Tightening Torque Value Update for Final Drive Pulley Retaining Nut and Side-stand Fastener
Models: 2016-2017 Model Year XDiavel and XDiavel S (all country versions)
Recall Bulletin SRV-RCL-16-003 (A & B)

Date: October 3, 2016
To: Dealer Principal, General Manager, Service Manager, North American Dealer Network
From: Richard Kenton, Technical Director; Jonathan LaForte, Technical Manager

NHTSA Campaign I.D. Number (A): 16V679
NHTSA Campaign I.D. Number (B): **XXX**
Transport Canada Safety Recall I.D. Number 2016472

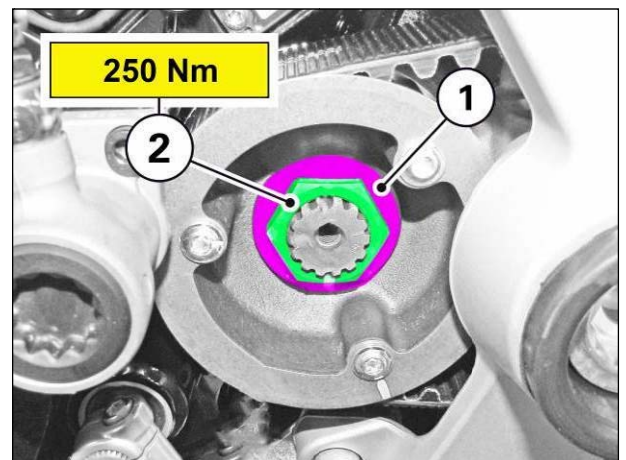
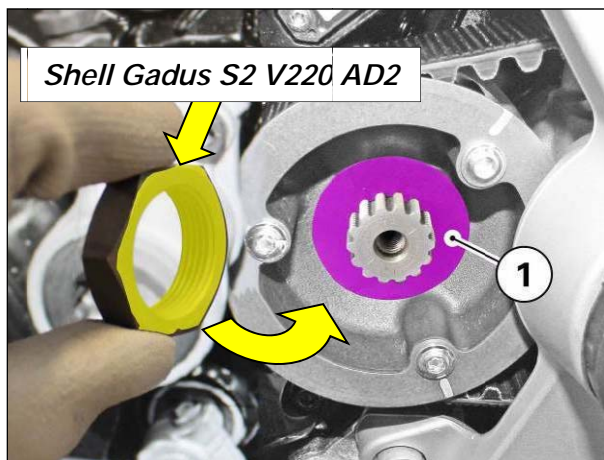
4) Fit the **lockwasher part no. 85110181B (1)** featuring a new material.

Tighten the new final drive pulley retaining **nut part no. 75010071A (2)** to a torque of **250 Nm**.

Apply SHELL GADUS S2 V220 AD2 grease on the nut thread and on the nut-washer mating surface.

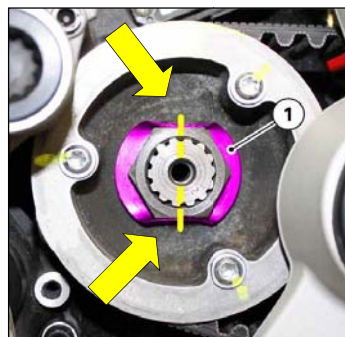
5) Bend the **lockwasher part no. 85110181B (1)** at 2 opposite points, against the relevant nut surfaces. Certify the tightening with a felt pen as shown in the figure (mark gearbox secondary shaft, nut, washer and pulley surface).

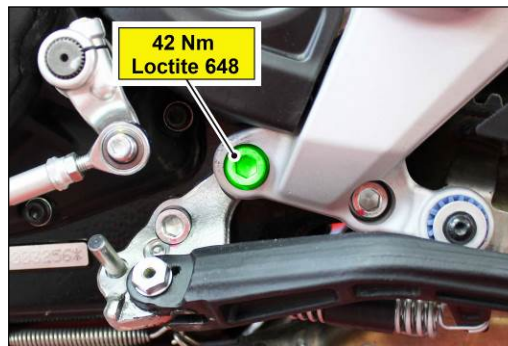
Replace the lower fastening screw with a longer one (from 28 mm to 30 mm) having a higher strength class (from 8.8 to 10.9) to increase the tightening torque to 65 Nm, with application of Loctite 648 (high-strength threadlocker). The new screw part no. is 77151568C.

Apply Loctite 648 (high-strength threadlocker) on the upper fastening screw and tightening torque of 42 Nm.

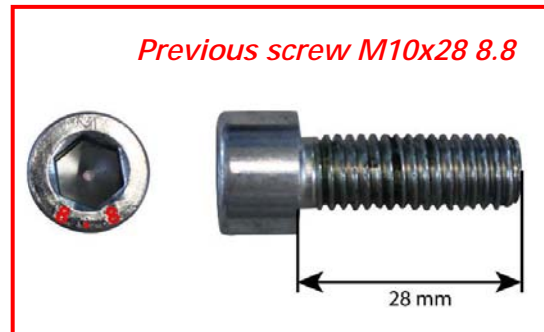
Replace side stand pivot with part no. 82118401AA and use a tightening torque of 24 Nm + LOCTITE 243.

24 Nm
Loctite 243

18 Nm
Loctite 243

b) SIDE STAND FASTENER - STEP 1

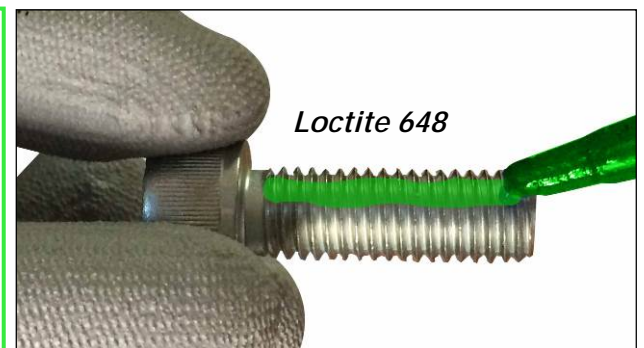
- Remove screw M6x1 that retains the side stand switch.
- Remove the *previous screw M10x28 8.8 (1)*.

- Take *screw M10x30 10.9 part no. 77151568C* and apply *Loctite 648* all along the threads:

- Tighten the new screw M10x30 10.9 part no. 77151568C to a torque of **65 Nm**.

b) SIDE STAND FASTENER - STEP 2

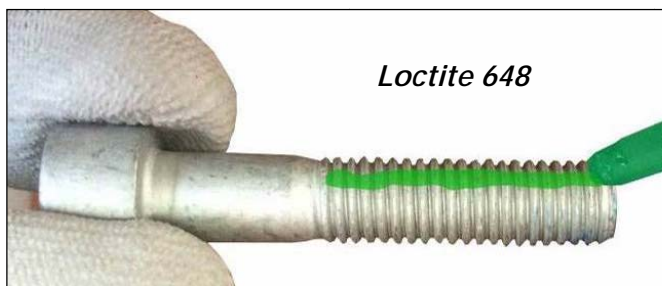
- Remove **screw M10x50 (2)** and properly clean the threads from Loctite previously applied.

The screw M10x50 (2) must NOT be changed and must be reused.

Apply Loctite 648 all along the threading of **screw M10x50 (2)** and tighten to a torque of **42 Nm**.

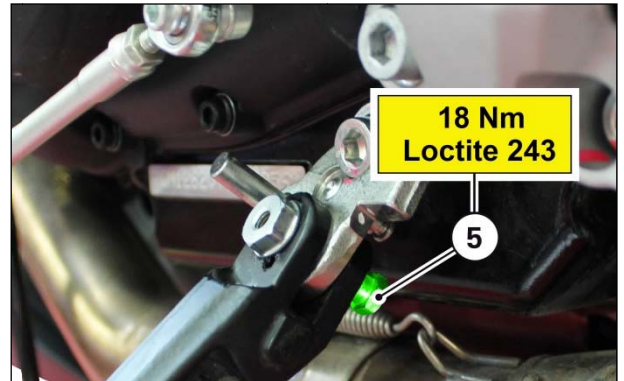
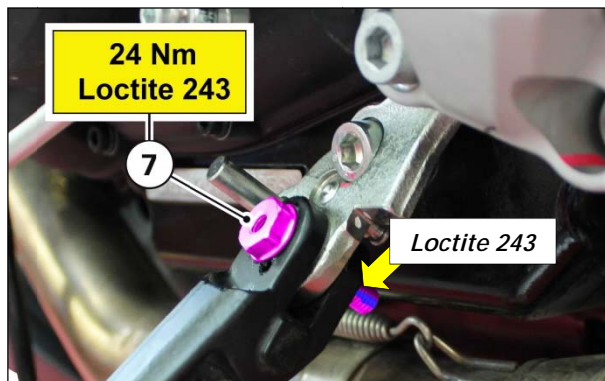
- Take the new ***pivot part no. 82118401AA*** and smear the cylindrical part with Shell GADUS S2 V220AD2 grease and the whole threading with Loctite 243.

- Insert ***pivot part no. 82118401AA (7)*** and tighten to **24 Nm**.

Apply LOCTITE 243 on threaded projection of pivot (7).

Start ***nut M8x1.25 (5)*** and tighten it to a torque of **18 Nm**.
